Subject: Skyline College Athletic Team Room Project
San Mateo County Community College District
SMCCCD Bid #
SMCCCD Project No.

Date: November 3, 2015

ADDENDUM NO. 1

DA#1

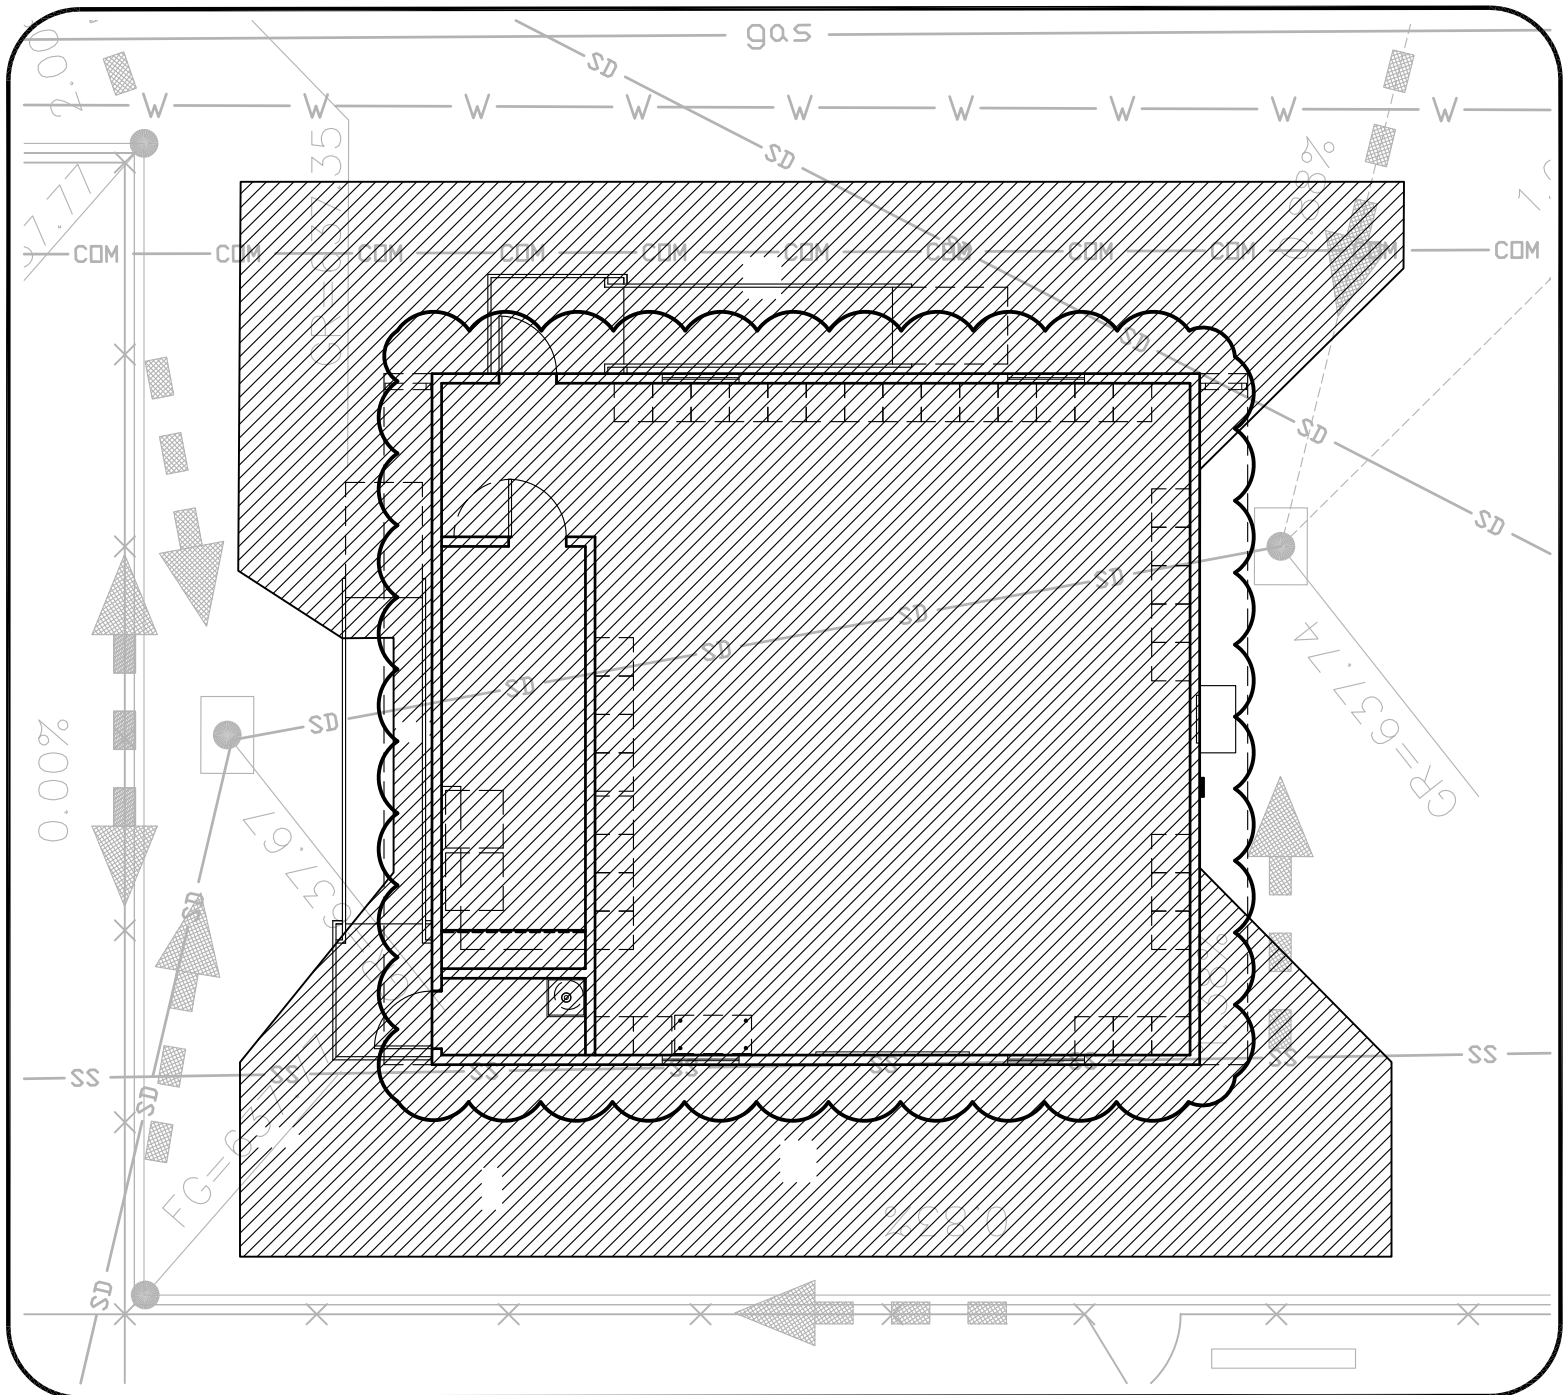
- Item #1 **Grading and Utilities Plan, Sheet L5.0.** CHANGE: Length and connection points for both the sanitary sewer and domestic water lines have been modified to match with point of connections at new modular building. Refer to Drawing Attachments #1 and AD1-P1 for additional information.
- Item #2 **Layout and Material Plan, Sheet L6.0.** CLARIFICATION: New asphalt paving shown on layout and material plan shall extend to under the building as well and not just the outer edge of the building. Refer to Drawing Attachment #2 and #3 for additional information.
